MCA response to U.S. Comments

Comments of Flash Airlines upon draft final report into the loss of Flash Airlines Flight 604

13.0 Right Roll Continues to Overbank with Aileron Activity

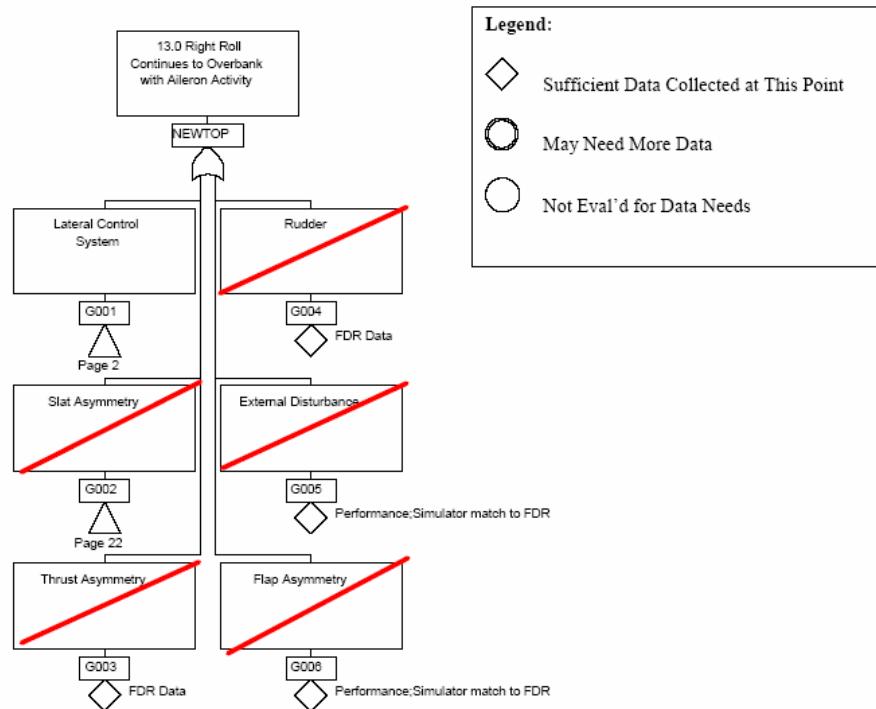
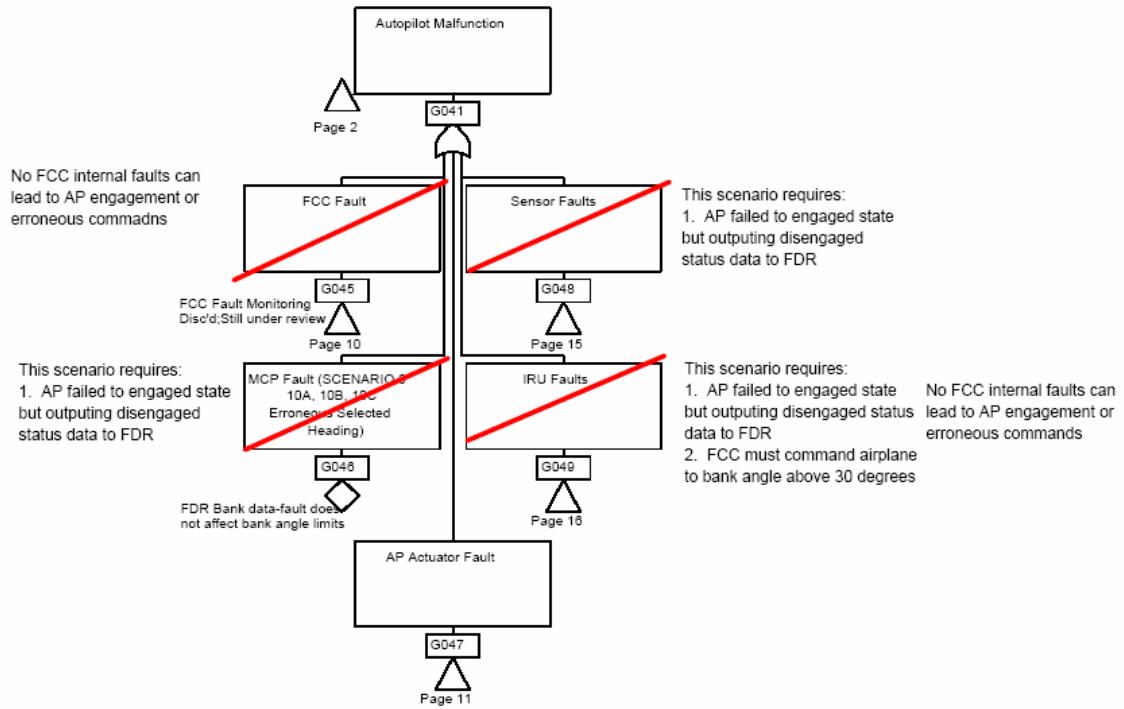
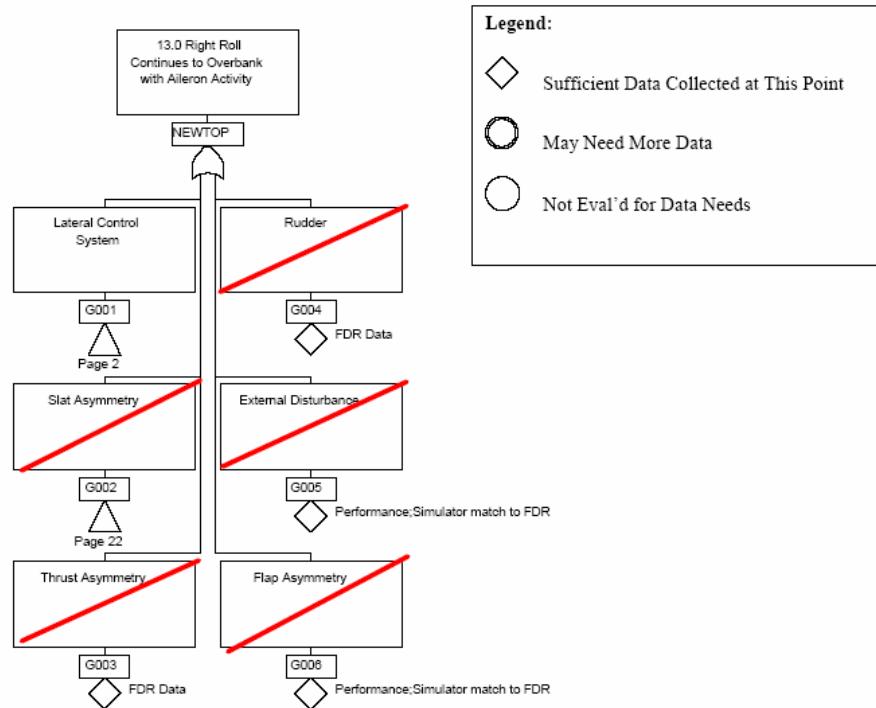
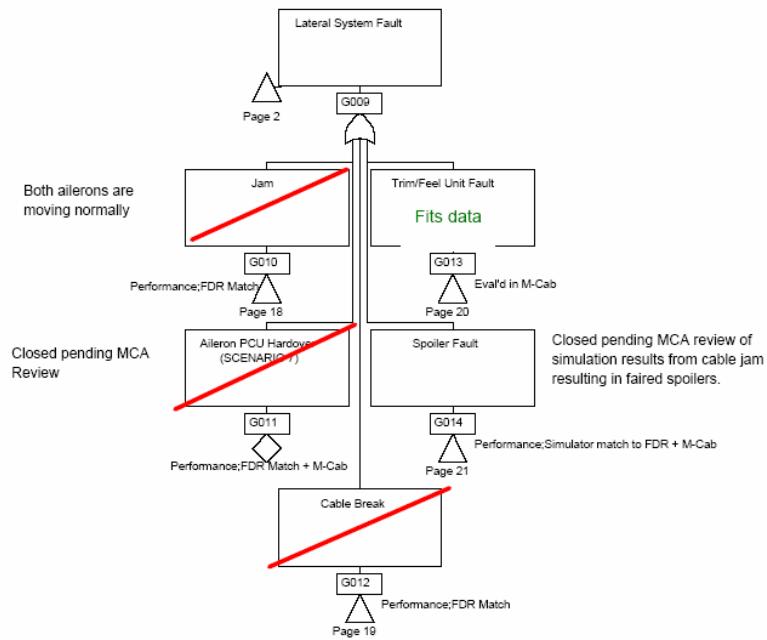
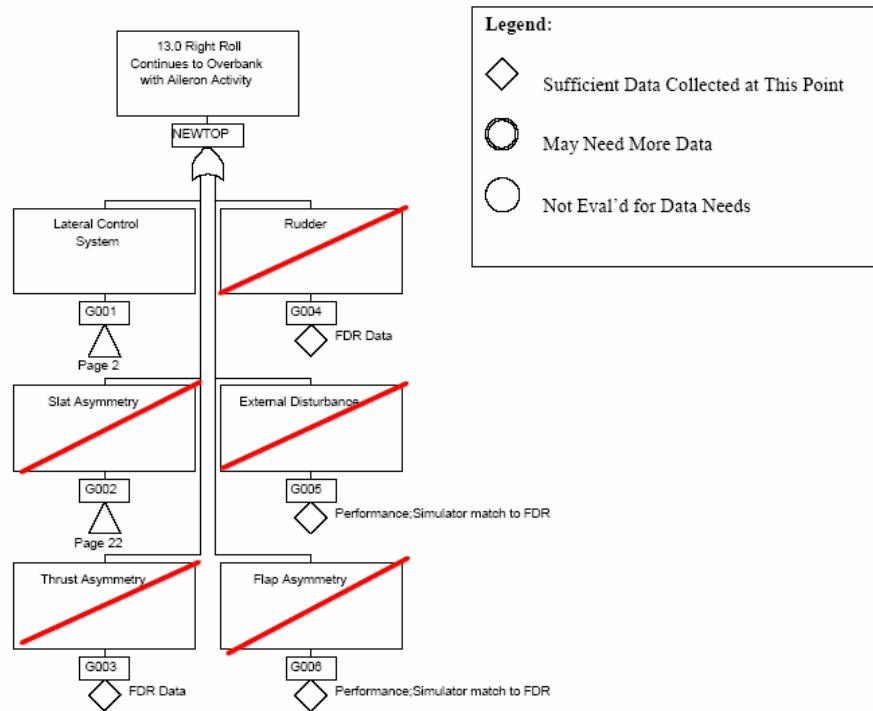
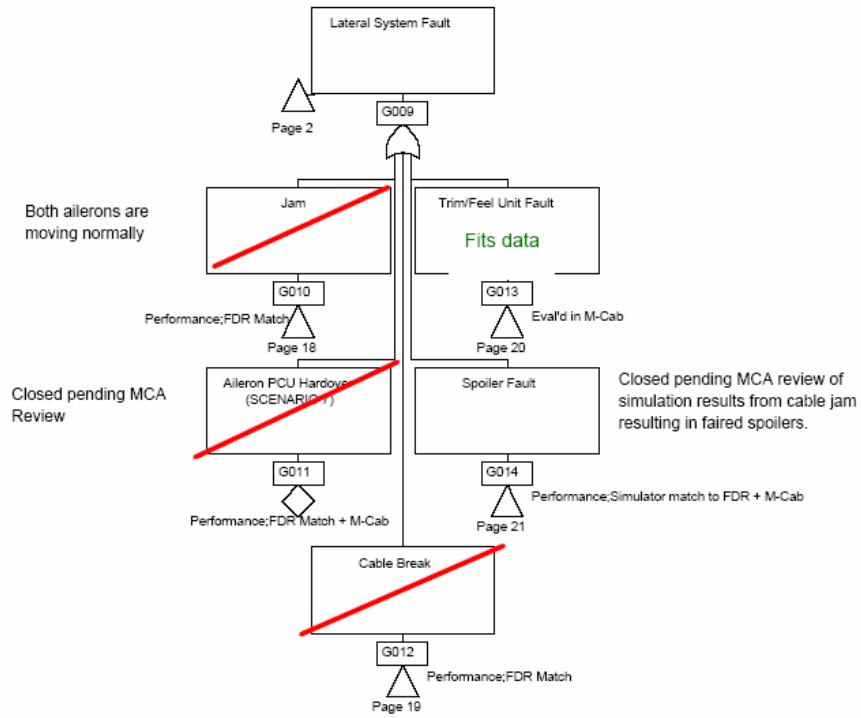
Specifically, no evidence of any airplane-related malfunction or failure was found. The exhaustive examination of the 737's autopilot and lateral control systems identified no fault that could explain the airplane's motion during the accident flight. In fact, as the MCA's draft final report properly concludes, the accident airplane's motion is consistent with the flight control movements recorded on the flight data recorder.

Referring to the Fault tree analysis (13.0 Right roll Continues to overbank with aileron activity), it could be noted that the analysis did not lead to the above conclusion. Also, the analysis does not

support the above U.S. statement. Had this been the case, these scenarios would have been ruled out as the rest of scenarios considered by the fault tree.

3- Spoilers wing cable jam and F/O wheel jam were not ruled out (refer to pages 1, 2, 17, 21 of the fault tree)

Results of the M-Cab test (This test was done on Boeing M-Cab, Seattle, Washington):

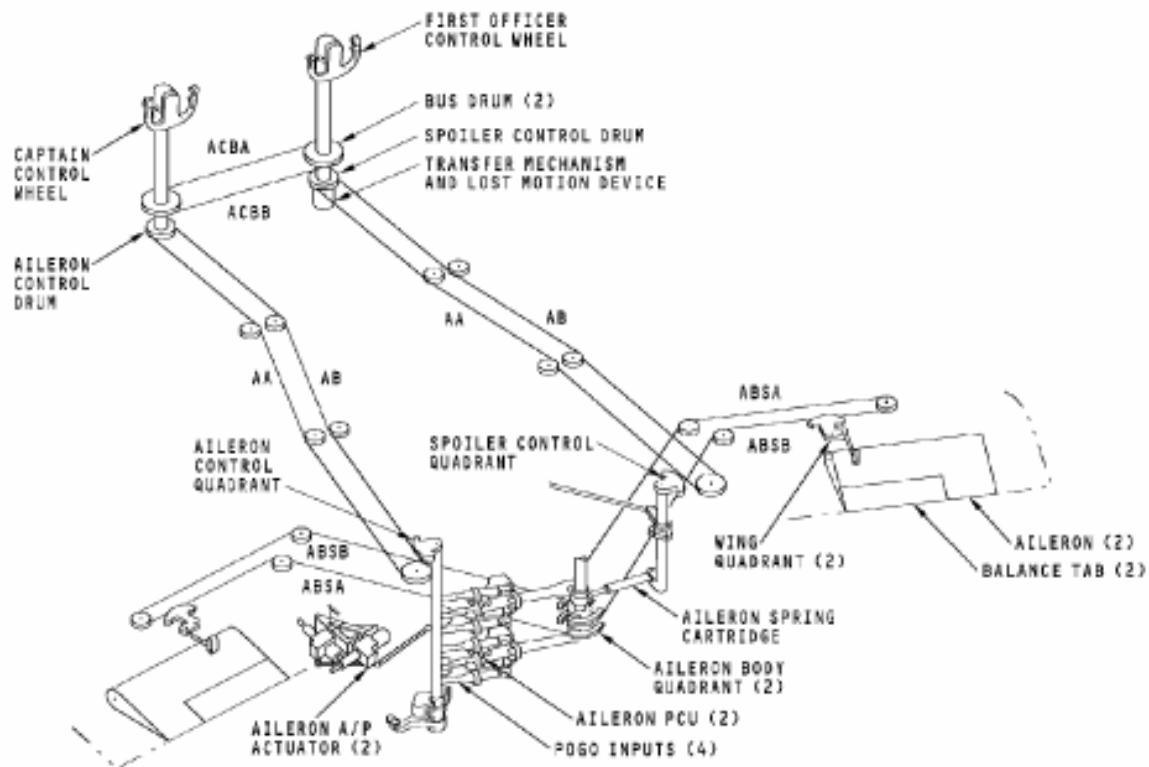
Aileron trim runaway. The MCA's draft final report accurately stated that an aileron trim runaway had not occurred before the autopilot was disconnected. After the autopilot was disengaged and as the airplane continued to roll to the right, FDR data showed aileron deflection rates well in excess of the aileron trim actuator rate of 0.6° per second. The rates recorded by the FDR could only have been achieved through manual wheel input because they exceeded the capabilities of the aileron trim system. Further, during flight simulations in Boeing's Multipurpose Engineering Cab (M-cab) simulator, investigators easily identified and controlled the aileron trim runaway and demonstrated that only 15 pounds of control wheel force were required to return to and maintain the aileron surfaces at the neutral position.

M-Cab results confirmed the analytical studies for the failure.

This fault could not be ruled out, based on the following:

- The results obtained from the analytical studies and the M-Cab test show a very close consistency with the available data.
- The airplane behavior is consistent with the consequences of the hypothetical fault:

Figure 2.5.13.15b Scenario 10 - Spoiler wing cable jam (lateral parameters)

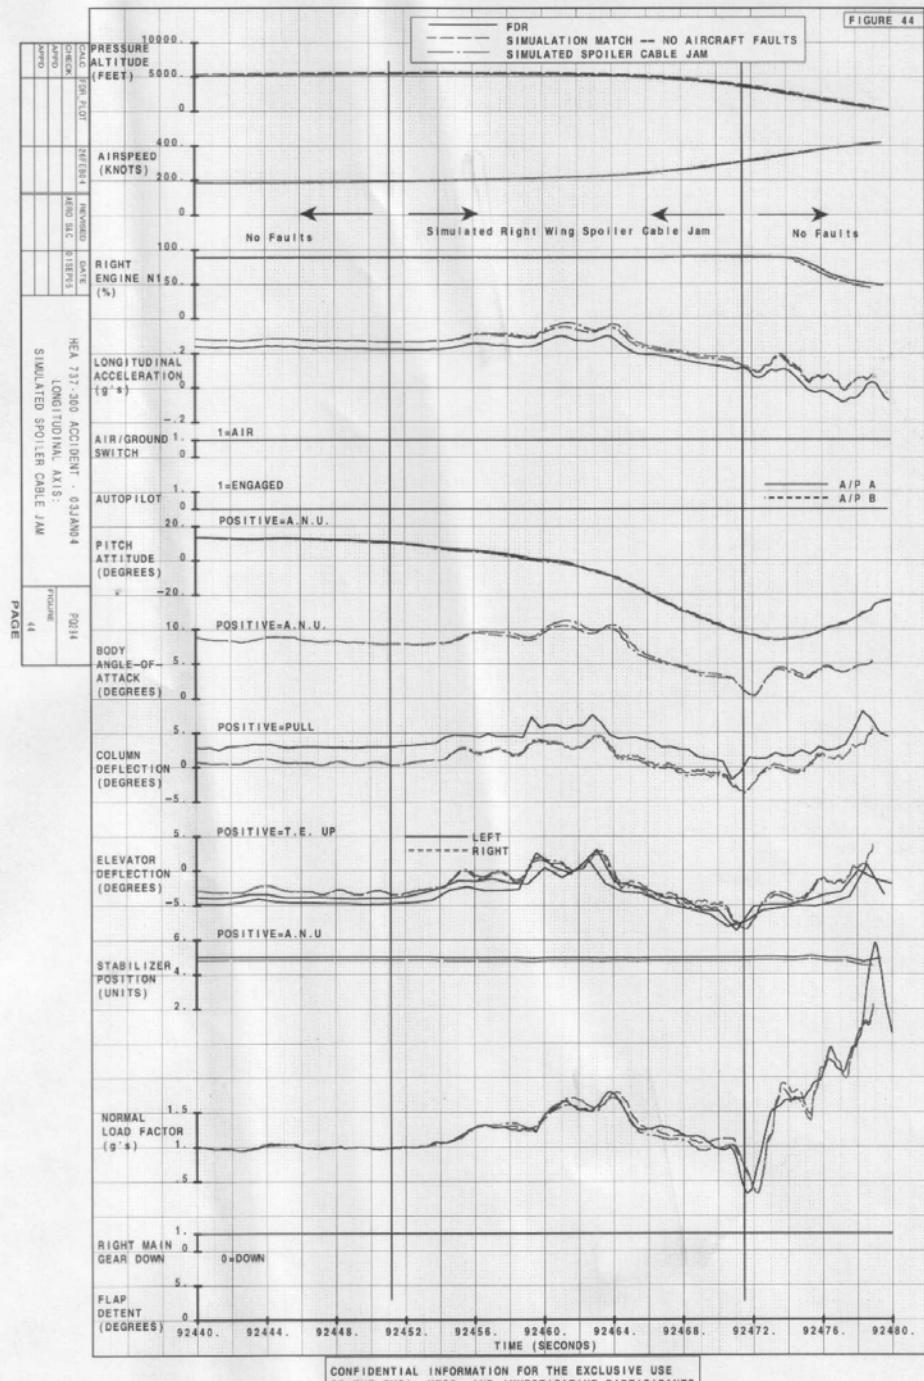
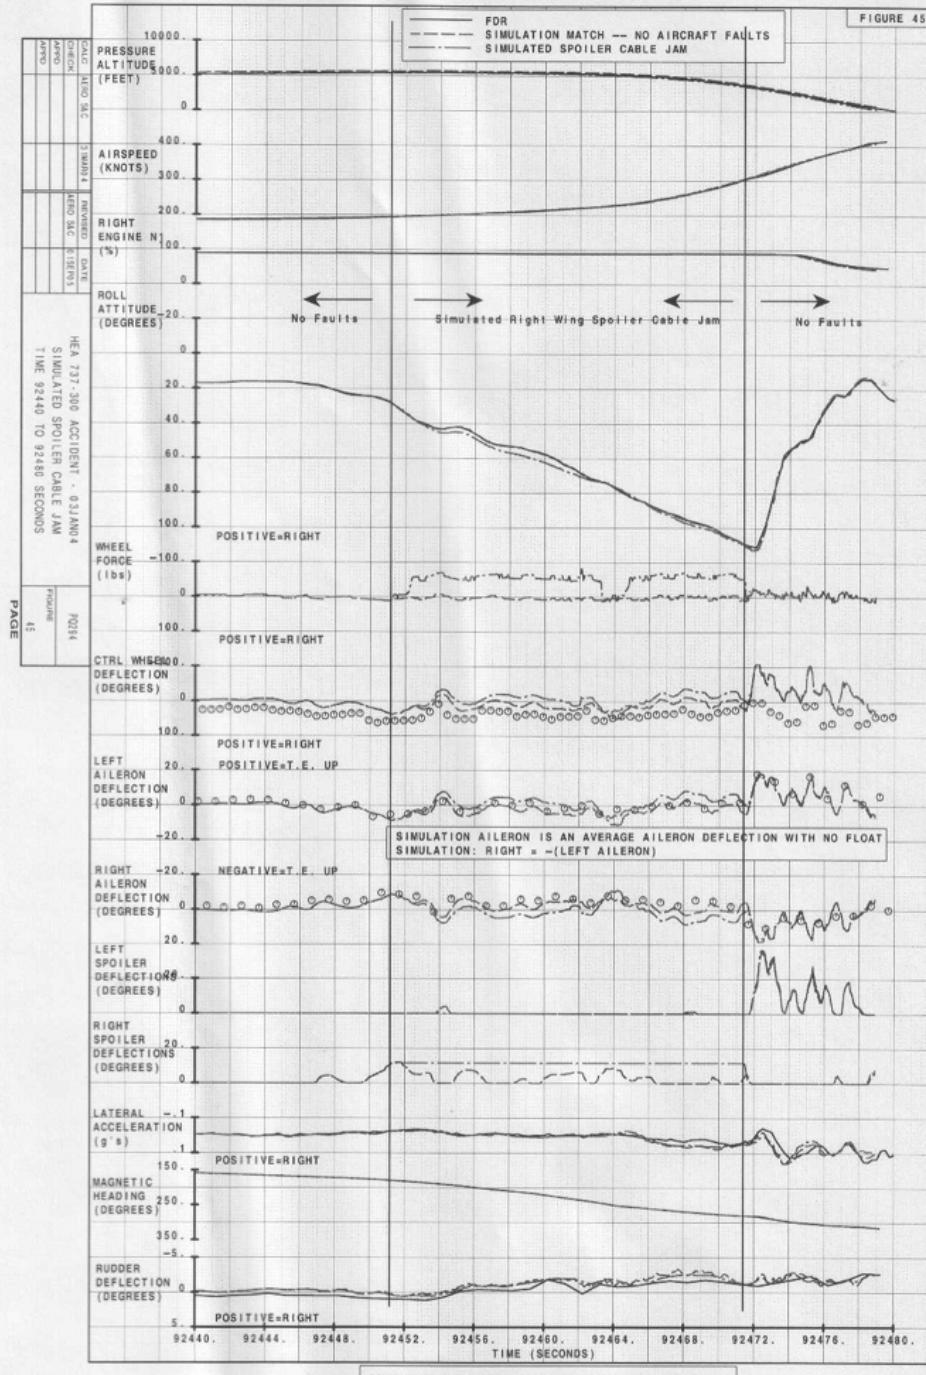
The MCA subsequently proposed two additional hypothetical failure scenarios: a temporary spoiler wing cable jam and a temporary first officer control wheel jam. The MCA's draft final report properly concluded that the accident airplane's motion is defined by FDR- recorded control surface deflections, including spoiler and aileron (control wheel) deflections. The effects of a temporary spoiler wing cable jam or of a temporary first officer control wheel jam would render the previous statement (and the simulation data analyses upon which it is based) false. Therefore, considering these hypothetical failure scenarios is illogical.

Further, the MCA's draft final report did not explain how the airplane got to the point in the right roll at which the temporary jams supposedly occurred. Initially, the airplane was in a left bank, but it then started banking right. The MCA proposes that the fault occurred as the airplane was increasing through a bank angle of about 25°; however, the airplane's initial departure from the 20°-left-bank attitude occurred about 45 seconds before the hypothetical faults would have started. In addition, the first officer's comment, "turning right, sir," occurred about 9 seconds before the hypothetical faults would have started.

As shown from the two plots, the results obtained from the M-Cab test show a very close consistency with the FDR data which may explain this event. The estimated aileron wheel forces needed to move the wheel to correct for the right turn tendency is ~ 50 lbs.

In response to the comment *'The MCA's draft final report properly concluded that the accident airplane's motion is defined by FDR- recorded control surface deflections, including spoiler and aileron (control wheel) deflections. The effects of a temporary spoiler wing cable jam or of a temporary first officer control wheel jam would render the previous statement (and the simulation data analyses upon which it is based) false'*, the statement is incorrect due to the close consistency showed in above.
